ADDENDUM No. 10
 TO THE
 CITY OF FRESNO
 PUBLIC WORKS STANDARD DRAWINGS AND SPECIFICATIONS
 ADOPTED MARCH 4, 1970, BY RESOLUTION NO. 70-36

THIS UPDATED VERSION IS APPROVED: JANUARY 13, 2025

Addendum 10 to the Public Works Standard Drawings and Specifications, dated January 13, 2025

CITY OF FRESNO
P-43

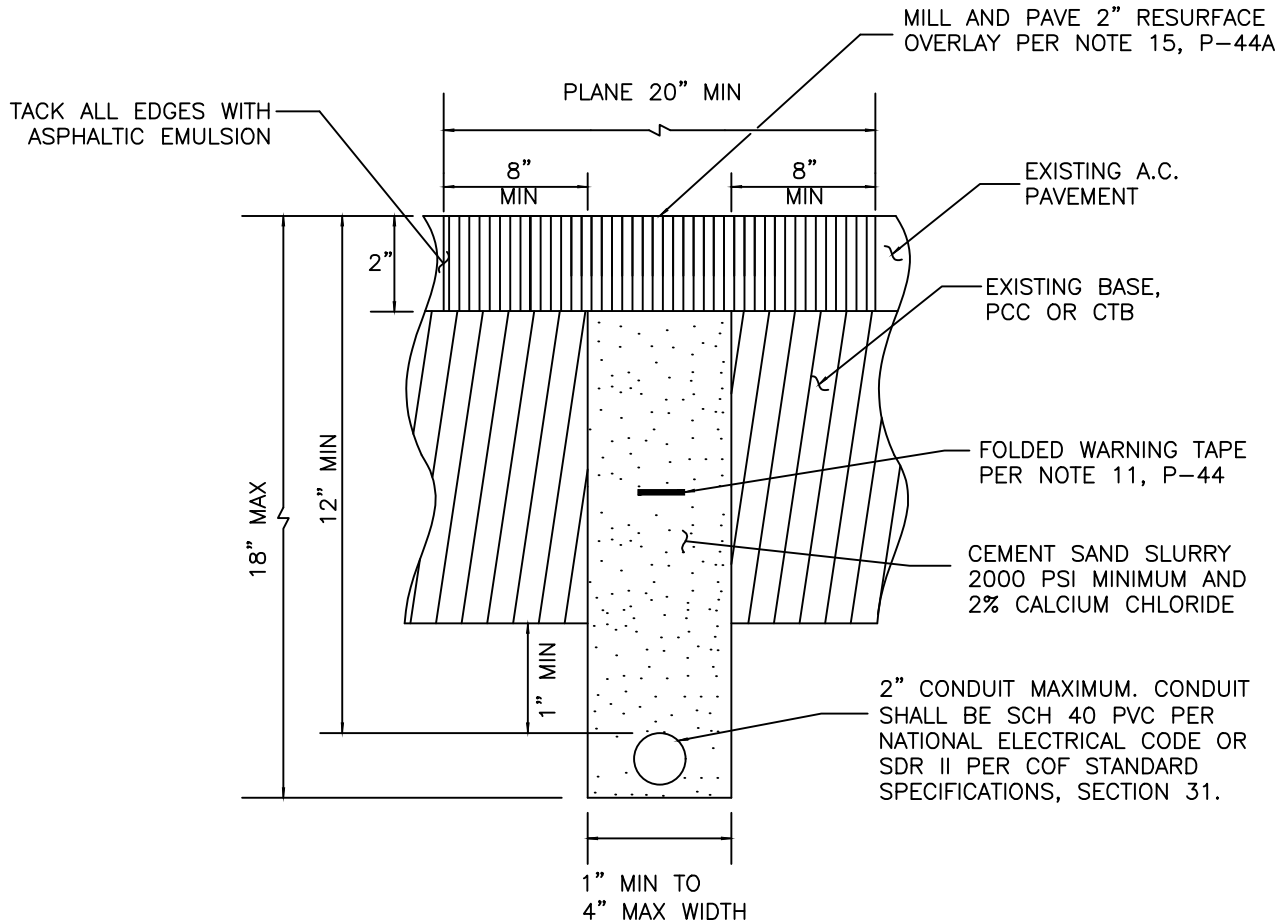
PUBLIC WORKS (P Series)	
P-43	1. Added Note 9 , TRENCH DETAIL CATV, LOCAL & MAJOR STREETS SHALL INCORPORATE APPLICABLE CITY STD. DWG. P-44 & P-44A GENERAL MICROTRENCH NOTES AS DIRECTED BY THE ENGINEER. 2. Drawing exhibit added hatching for trench cross section.
P-44	1. PREVIOUSLY NOT USED STANDARD. Adds microtrenching notes 1 to 14.
P-44A	1. NEW P DRAWING ADDED. Adds microtrenching notes 15 to 21.
P-46	1. PREVIOUSLY NOT USED STANDARD. Adds microtrenching drawing and notes for microtrenching in asphalt pavement.
P-49	1. PREVIOUSLY NOT USED STANDARD. Adds microtrenching drawing and notes for microtrenching in concrete (curbs, gutters, sidewalk & pavement).

9. TRENCH DETAIL CATV, LOCAL & MAJOR STREETS SHALL INCORPORATE APPLICABLE CITY STD. DWG. P-44 & P-44A GENERAL MICROTRENCH NOTES AS DIRECTED BY THE ENGINEER.
